## CAR16-00038, PUD16-00041 & SUB16-00069 / Little Wood Landing, LLC

# Planning Division Project Report

<b>File Number</b>	CAR16-00038, PUD16-00041 & SUB16-00069
<b>Applicant</b>	Little Wood Landing, LLC
<b>Property Address</b>	2641 N. Linda Vista Lane
<b>Public Hearing Date</b>	January 17, 2017
<b>Heard by</b>	Planning and Zoning Commission
<b>Analyst</b>	Cody Riddle

**PRELIMINARY PLAT**

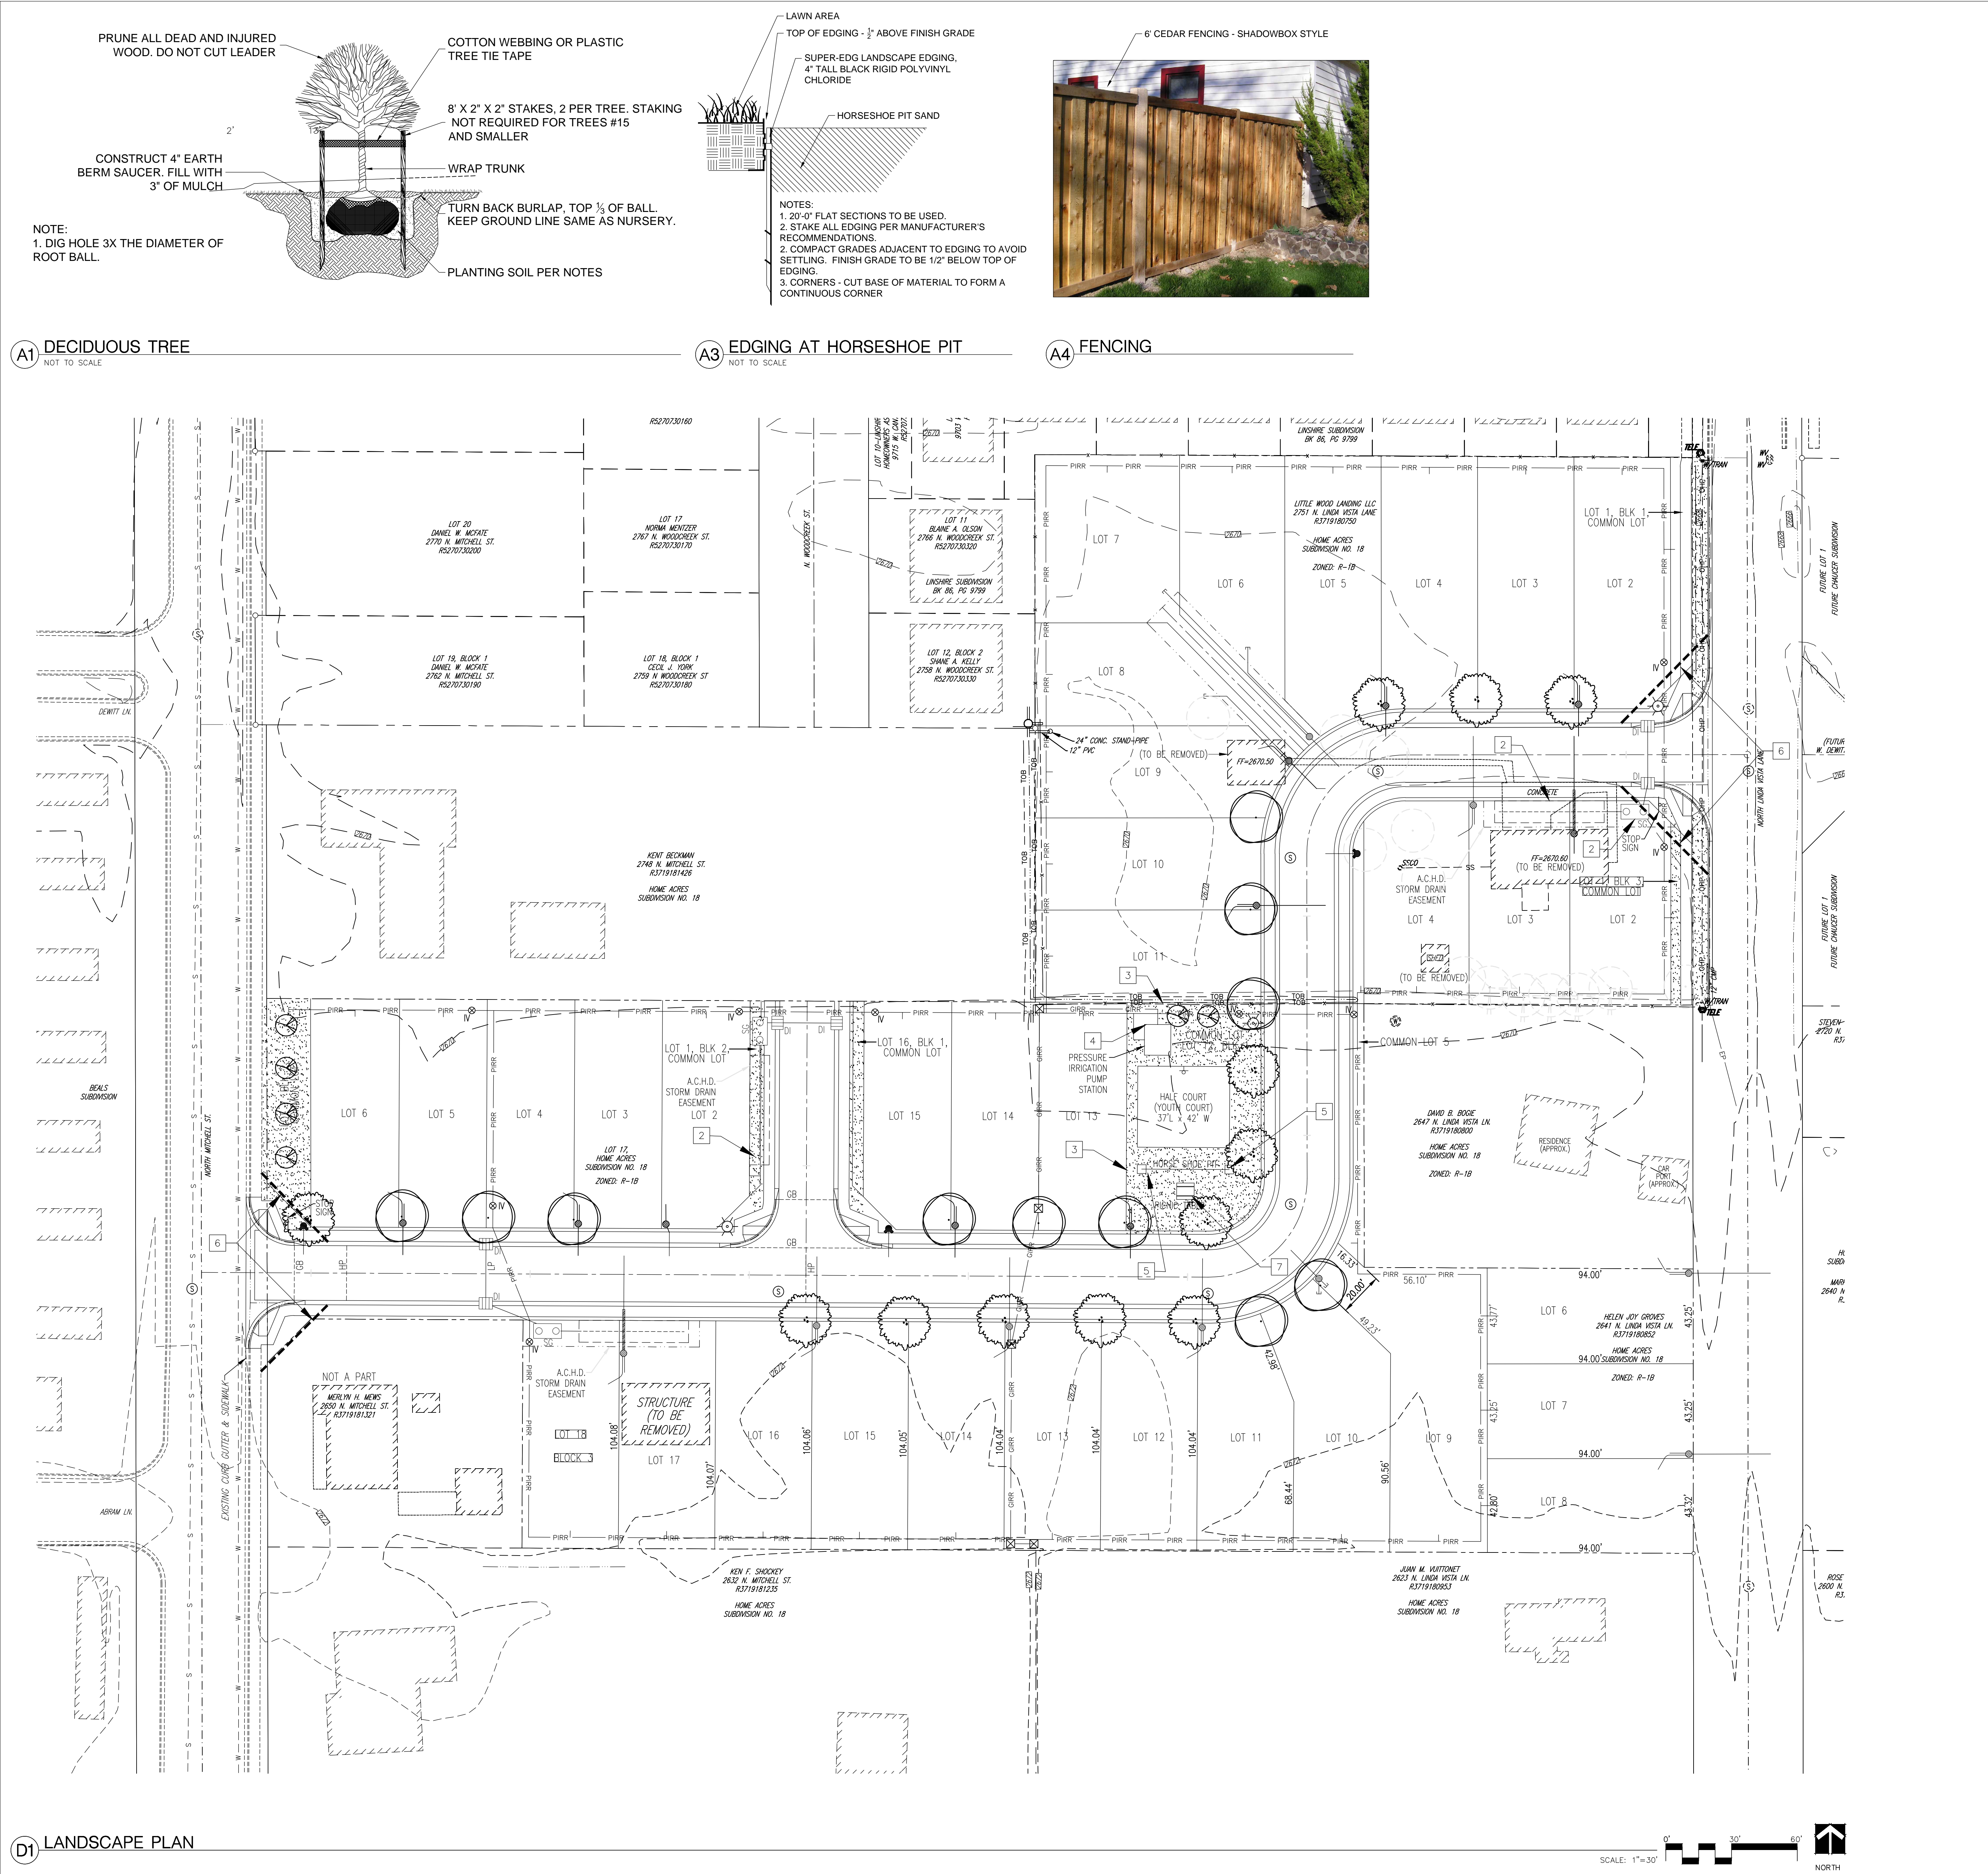
The applicant is proposing a continuation of attached sidewalk along Mitchell Street, and the site plan indicates a detached facility along Linda Vista, up to the outparcel. The plan does not indicate any sidewalk south of the outparcel. The applicant has indicated it is their intent to install detached sidewalk along the entire Linda Vista frontage. This has been included in the attached conditions. The site plan currently indicates an attached sidewalk on both sides of the interior street. However, the applicant has agreed to provide detached sidewalk along the south side. While detached sidewalk is typically preferred on both sides of the street, the Planning Team supports the applicant’s alternative in this instance. The extension of the public street through the project consumes a significant portion of the property, and results in a limited depth for building pads. Allowing an attached sidewalk on one side of the street mitigates some of this impact. This design treatment has been reflected in the attached conditions of approval.
